PLAN AND PROFILE OF PROPOSED STATE HIGHWAY

PRINCE WILLIAM PARKWAY INTERCHANGE AT REALIGNED BALLS FORD ROAD

VDOT Proj.No.6234-076-266

Notice of Design Change (NDC) #02
JUNE 2021

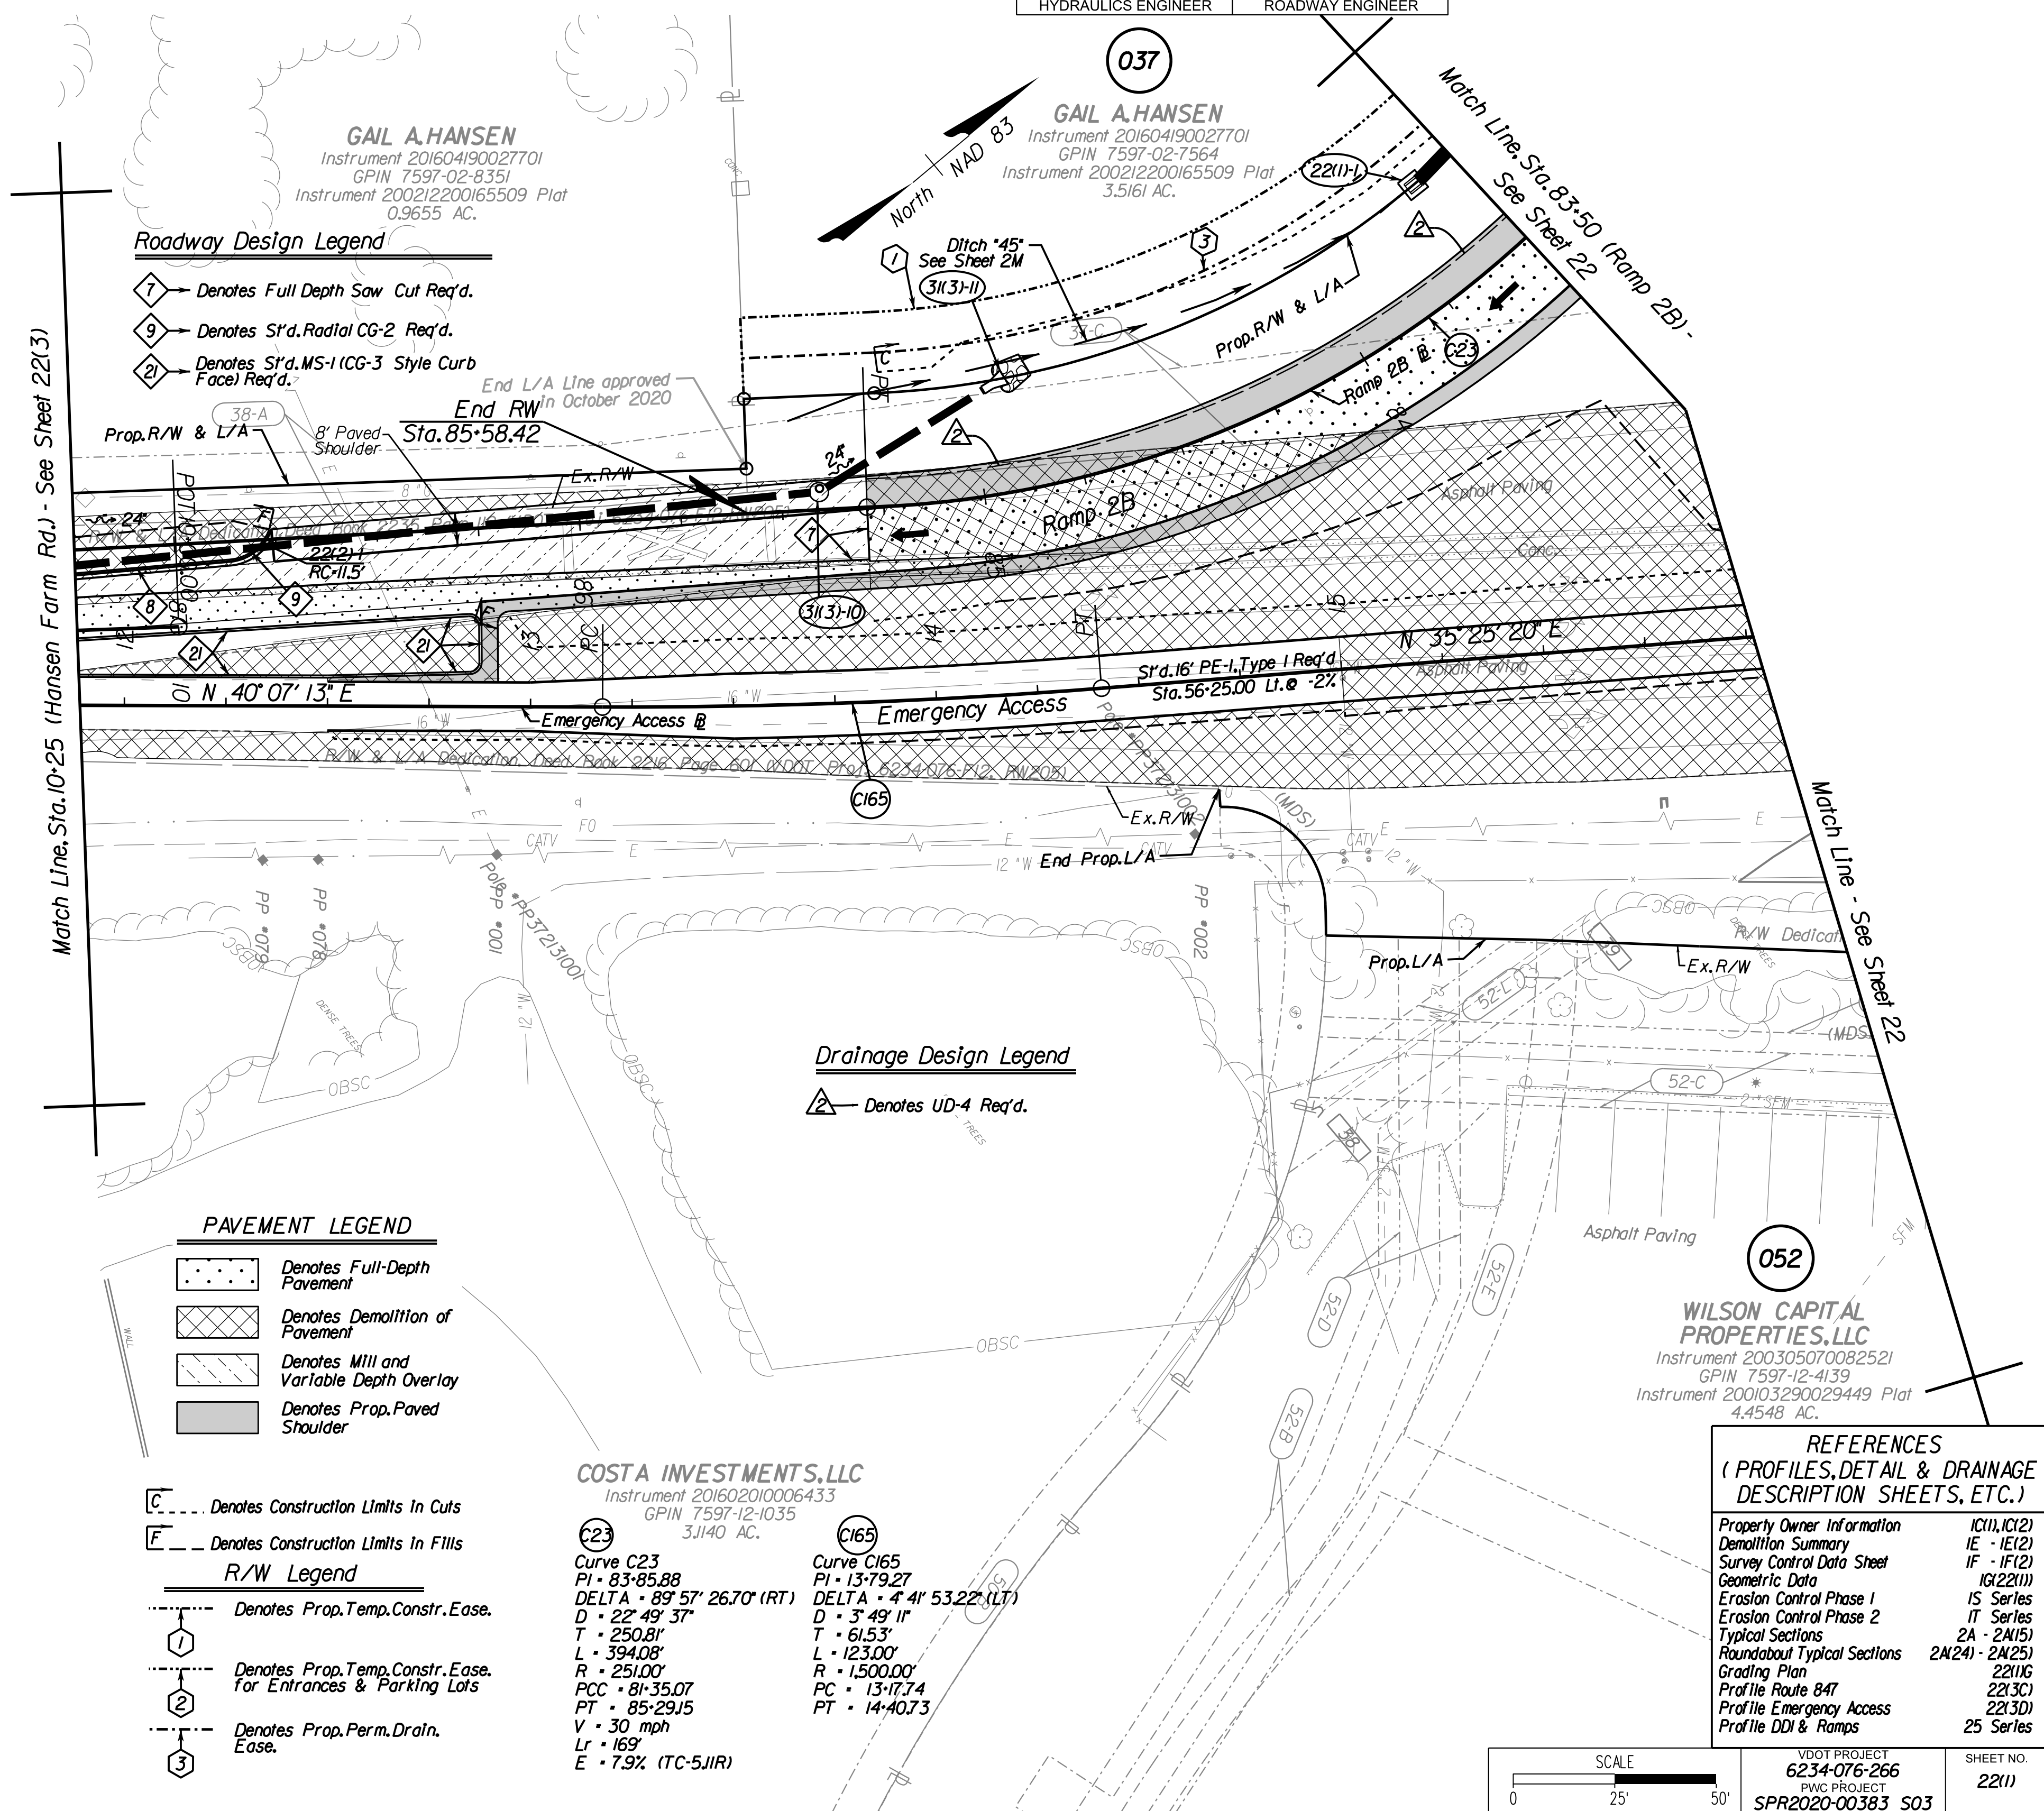
02 Revised cut/fill limits and ditch alignment. Added emergency access entrance. Added Right of Way to Parcel 037.

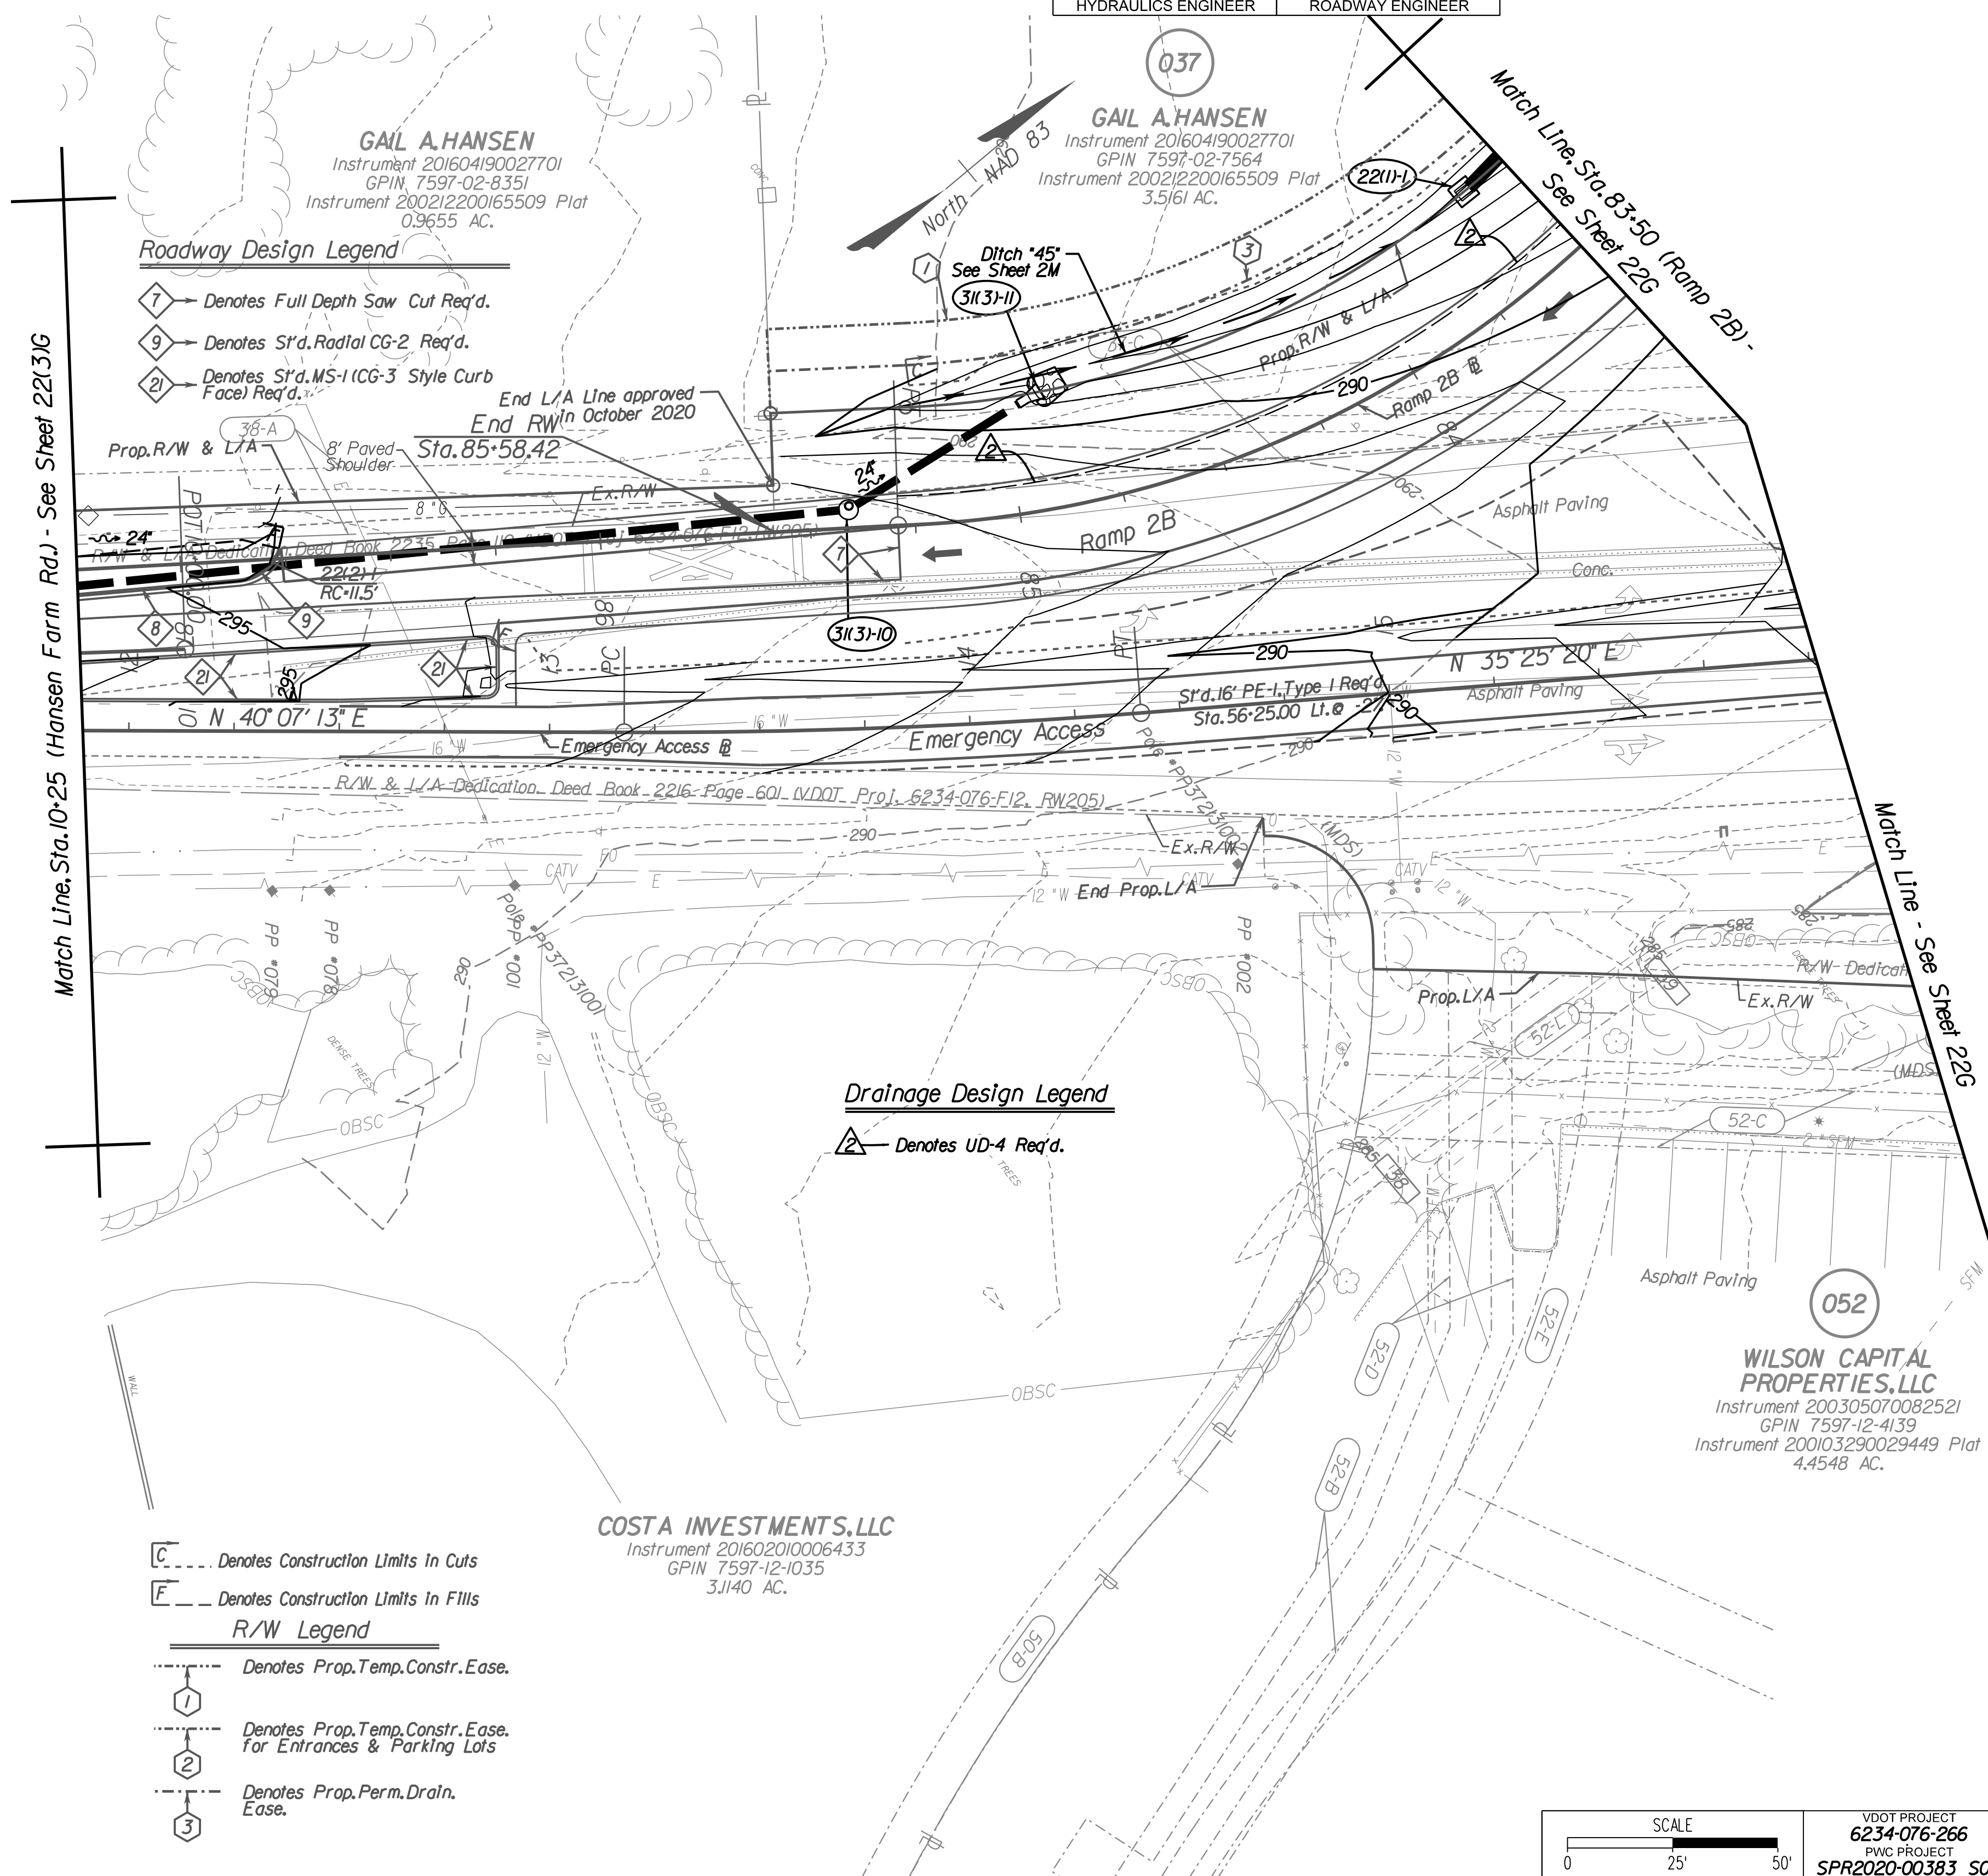
02 Revised grading and ditch alignment.
 Added emergency access entrance.

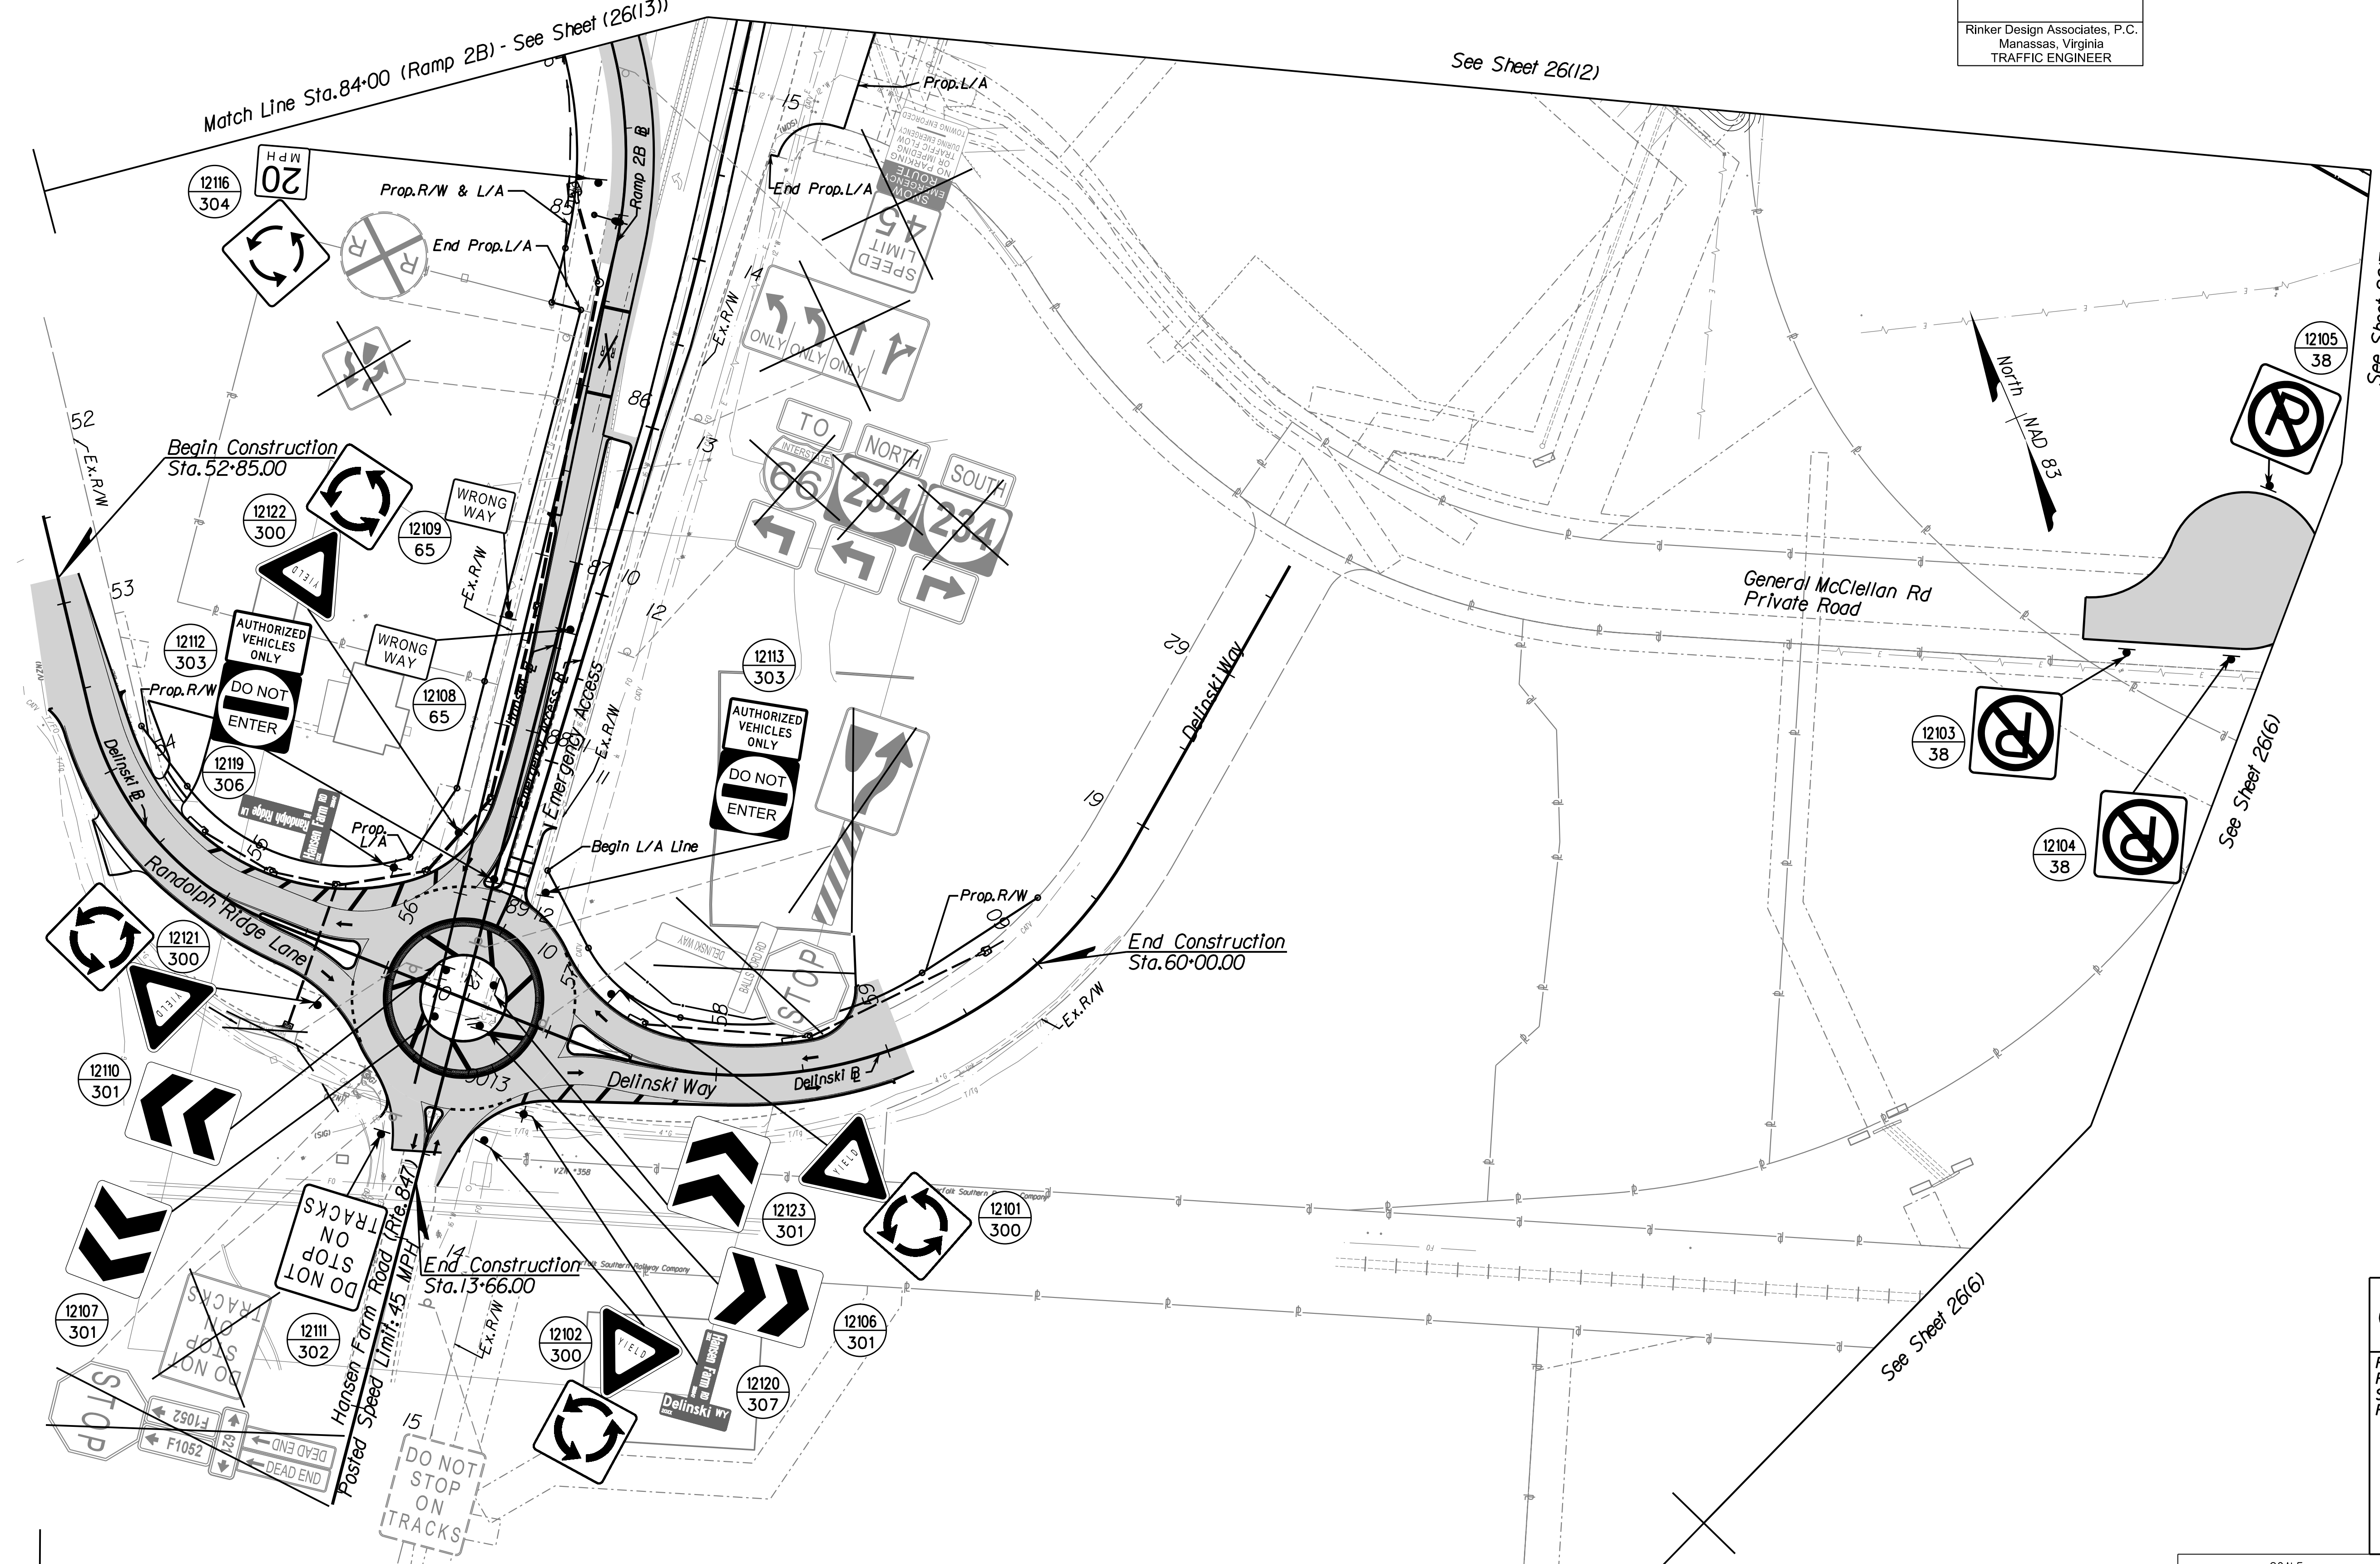
02 Revised sheet to include roundabout signage.
